1964 - 1966 Corvette: Service Bulletin: Gear Shift Control Assembly Buzz

Subject: Gear Shift Control Assembly Buzz

Bulletin No: TSB #66-65

Date: June 13, 1966

FIGURE 1

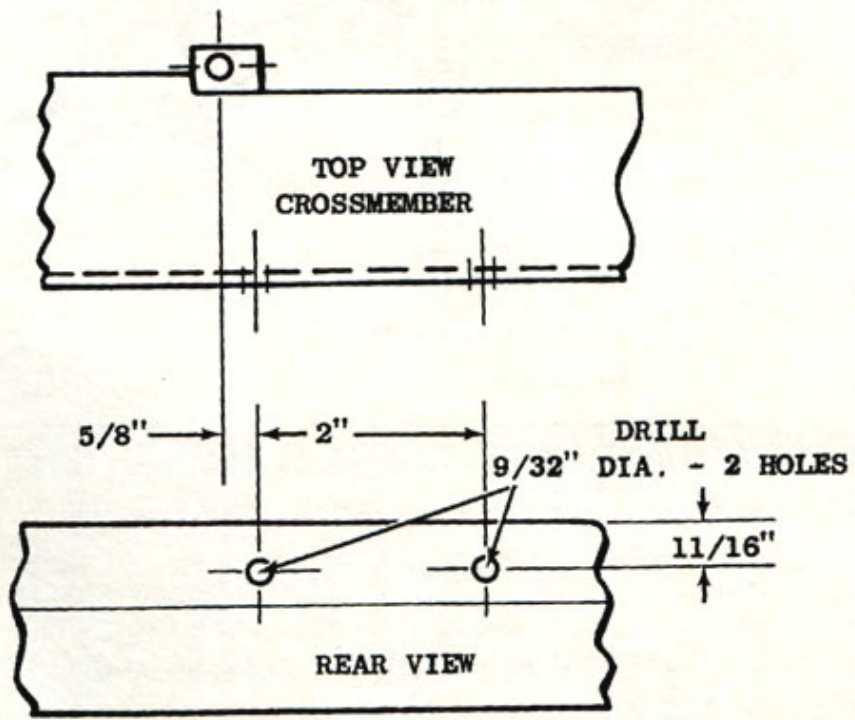
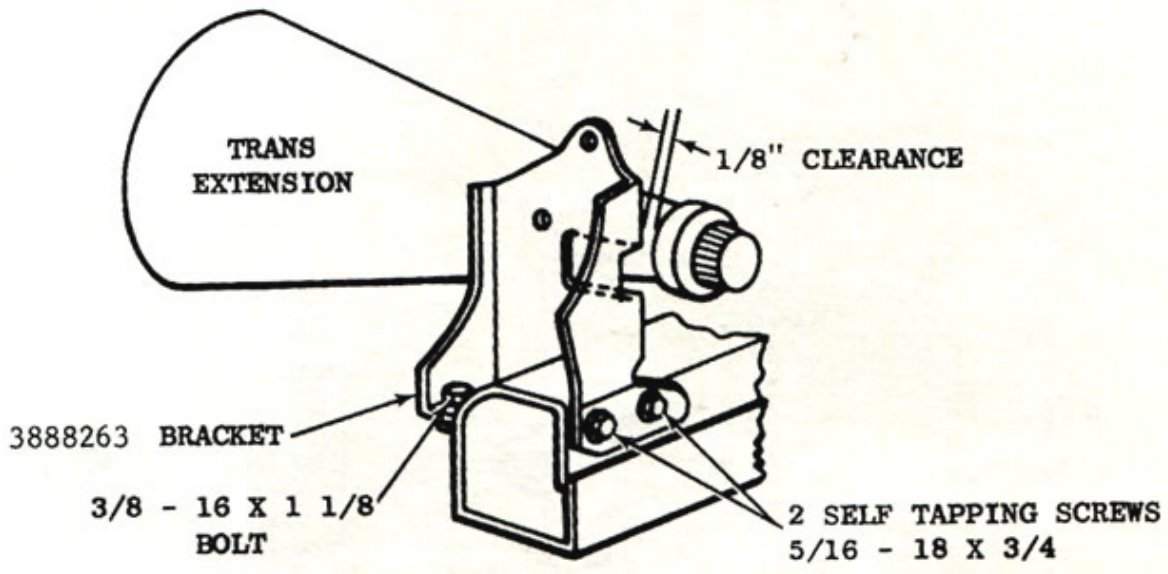
Complaints of shift control lever buzz on earlier units should be corrected by repositioning shift control assembly from the transmission housing to the frame crossmember. This is accomplished by removing the transmission extension mounting bracket and mounting the new bracket on the frame crossmember. Details of the repositioning procedure are covered on the following page(s).

7. Scribe a line 11/16" down from top surface of crossmember on rear side (See fig. 1.)
8. Move new bracket, Part No. 3888263, into position from rear of crossmember.

9. Loosely install bolt through front leg of new bracket through mounting tab on front of crossmember (center in slot). (See fig. 2, item 6.)
10. Using bracket as template, locate position of holes to be drilled at center of bracket slots. (fig. 1)

11. Remove bracket and drill two 9/32" holes in rear of crossmember. (See fig. 1.)
12. Loosely install new bracket using two 5/16" self-tapping screws and washers at rear attachment. (See fig. 2, items 4 and 5.)

15. Reinstall transmission mounting assembly and bracket and exhaust support. Tighten all bolts securely with exception of bolt holding new bracket.
16. Adjust new bracket laterally to provide desired 1/8"* clearance between transmission extension and bracket, then tighten bracket

screws securely. (See fig. 1.)

* Clearance in excess of 1/8" may cause binding in reverse operation.

FIGURE 2

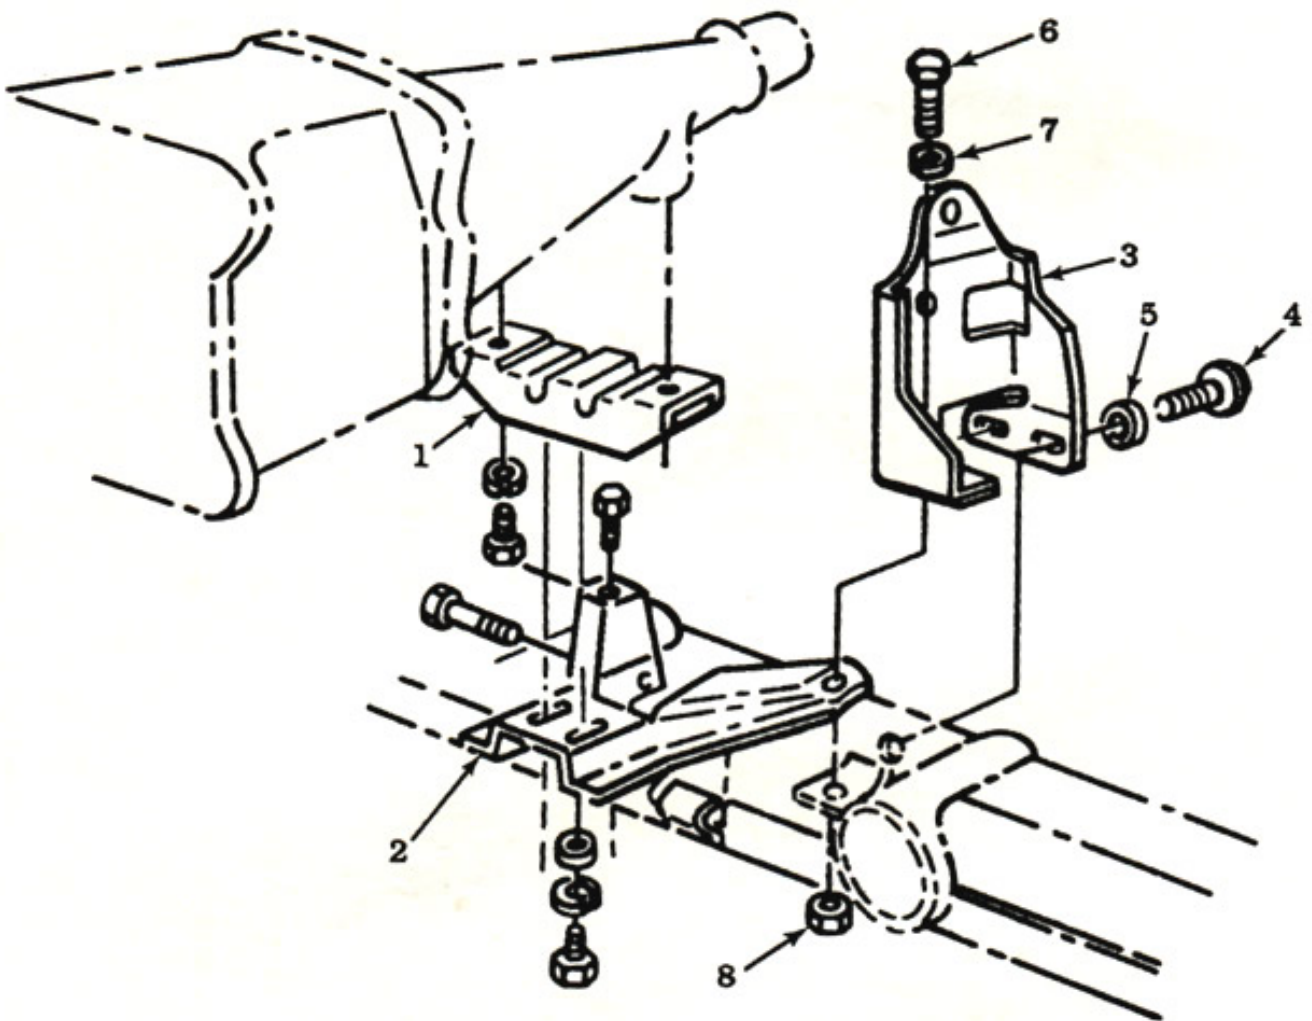
1. Remove shift levers at transmission.
2. Position jack stand under transmission and remove transmission mounting assembly and bracket. (See fig. 2, items 1 and 2.)
